CITY OF BOULDER
PLANNING BOARD MEETING AGENDA
DATE: August 21, 2014
TIME: 6 p.m.
PLACE: Council Chambers, 1777 Broadway

AGENDA TITLE: Public hearing to consider **Concept Plan**, LUR2014-00045, for the phased redevelopment of the 8.45-acre Armory site located at the southeast corner of Broadway and Lee Hill Dr. with a mixed-use project including the Phase 1 development of the western half of the site with 127 residential units, a 10,700 s.f. arts market/ studio space, 10,900 s.f. of retail/ flex space and up to 13,100 s.f. of restaurant space including a new 9,500 s.f. brew pub to be located in the existing “mess hall” building; and the Phase 2 development of the eastern half of the site with 65 mixed density residential units.

DATE OF COMMENTS: **July 7, 2014**
 CASE MANAGER: **Chandler Van Schaack**
 PROJECT NAME: **The Armory**
 LOCATION: **4750 BROADWAY**
 COORDINATES: **N09W06**
 REVIEW TYPE: **Concept Plan Review & Comment**
 REVIEW NUMBER: **LUR2014-00045**
 APPLICANT: **LIZ PETERSEN**

6 13th STREET - TYPICAL SECTION 3
Scale: 1" = 10 ft

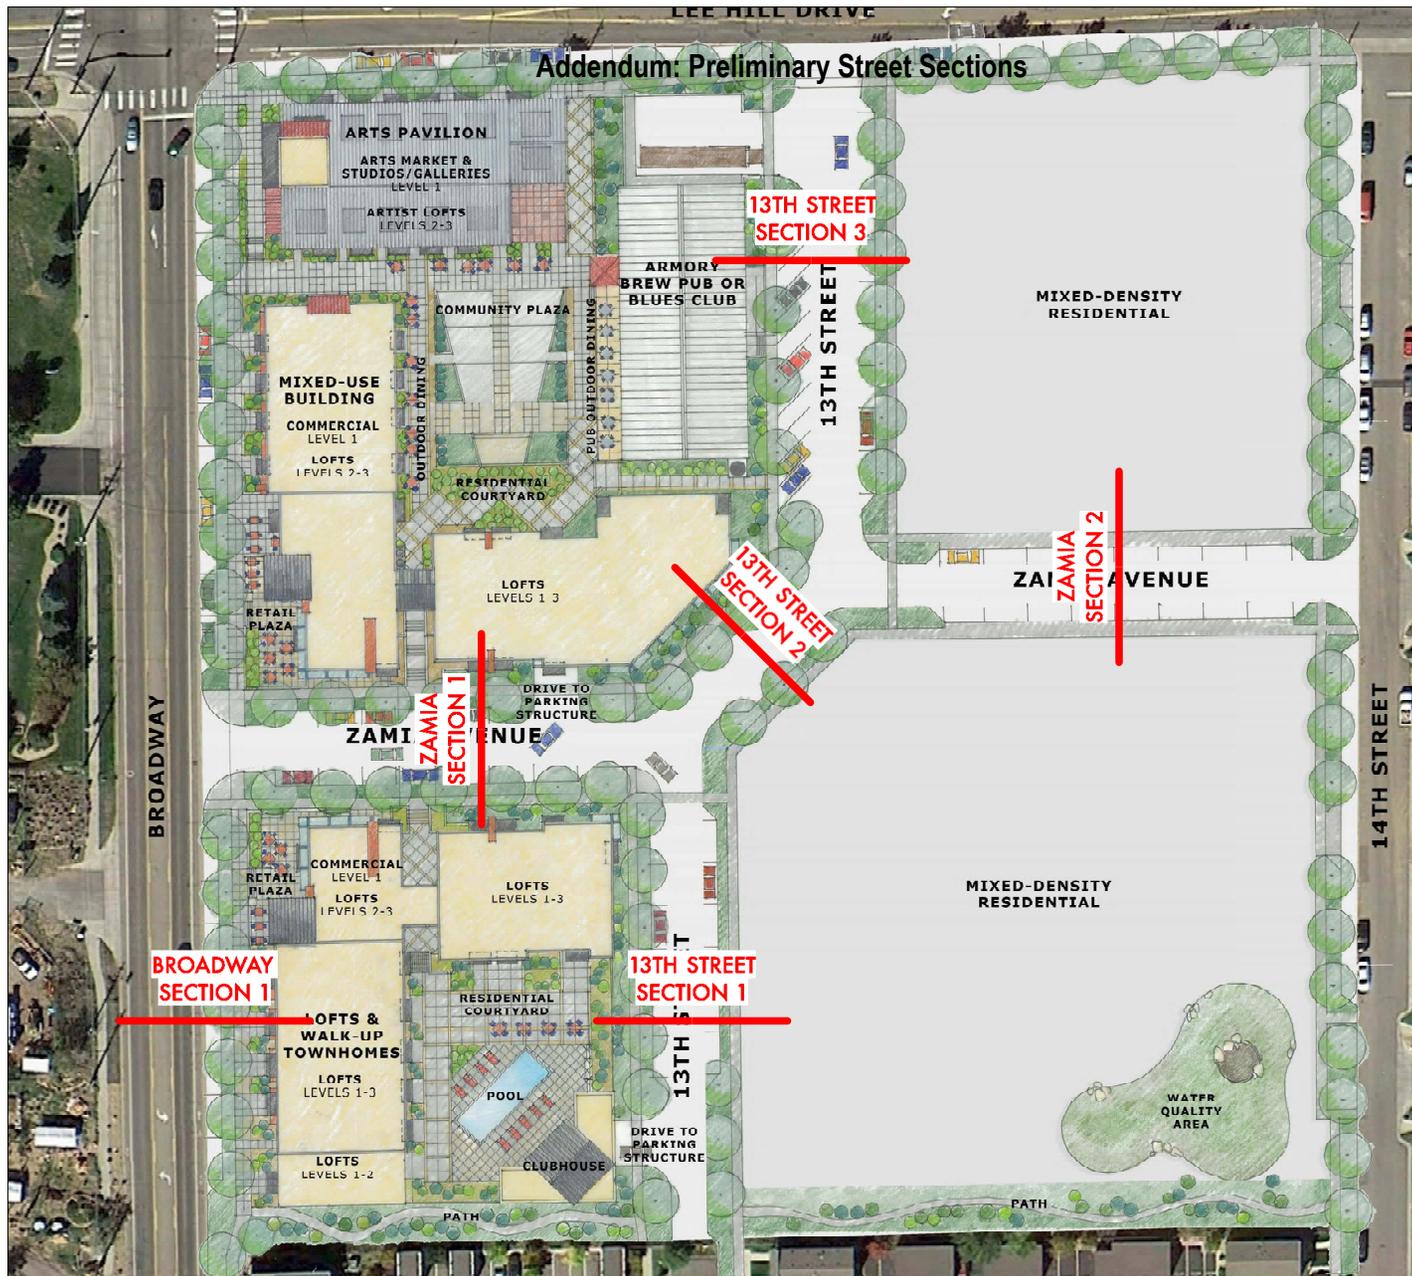
Overall, the proposed streets through the site are consistent with the NoBo Plan and will serve to enhance connectivity in the area and potentially reduce traffic on Broadway. The proposed street sections appear to be consistent with previous discussions with the applicant. Staff has some concerns regarding the alignment of the access points on Broadway and Lee Hill, which are outlined in further detail below.
